REMARKS

Objection to the Drawings

FIG. 8

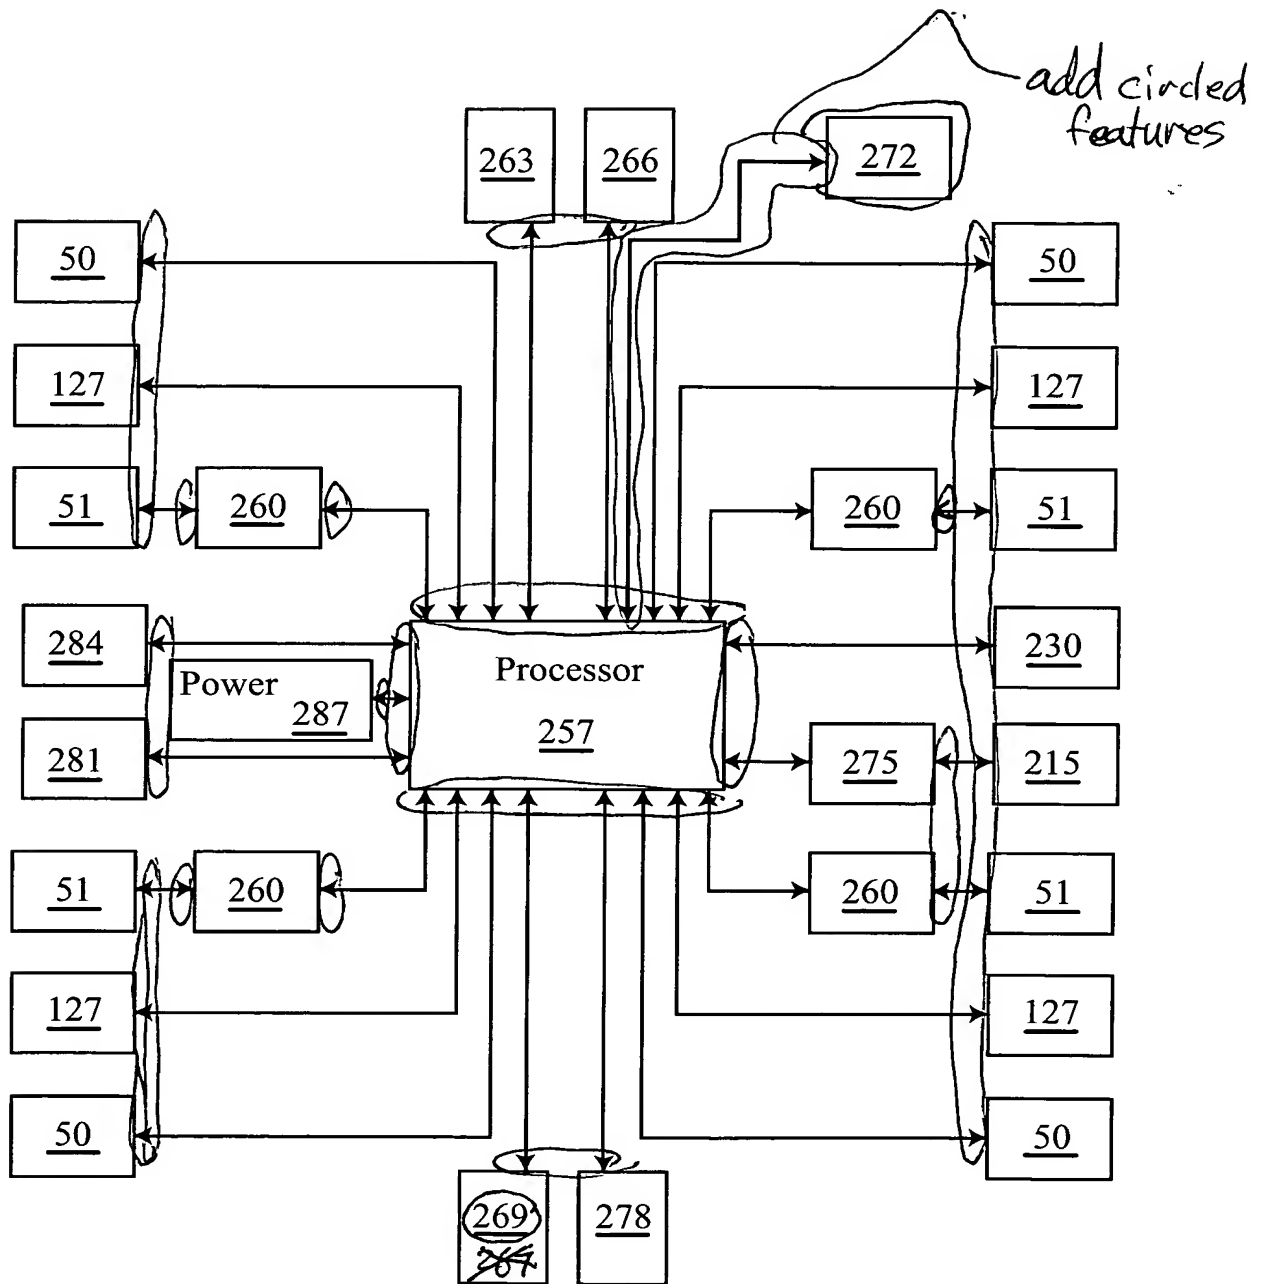
Regarding the objection to Figure 8, the figure has been modified to reflect that flow of signals may be in both directions. Support for this is found at page 23, lines 25-27 and page 24, lines 2-3 in which the ECU 257 receives feedback, sends out control signals, and provides responses based on input from the various electrical components.

Regarding nonexistence of reference numeral 269 in the figures, Figure 8 has been amended to include this reference numeral.

Regarding nonexistence of reference numeral 272 in the figures, Figure 8 has been amended to include this reference numeral.
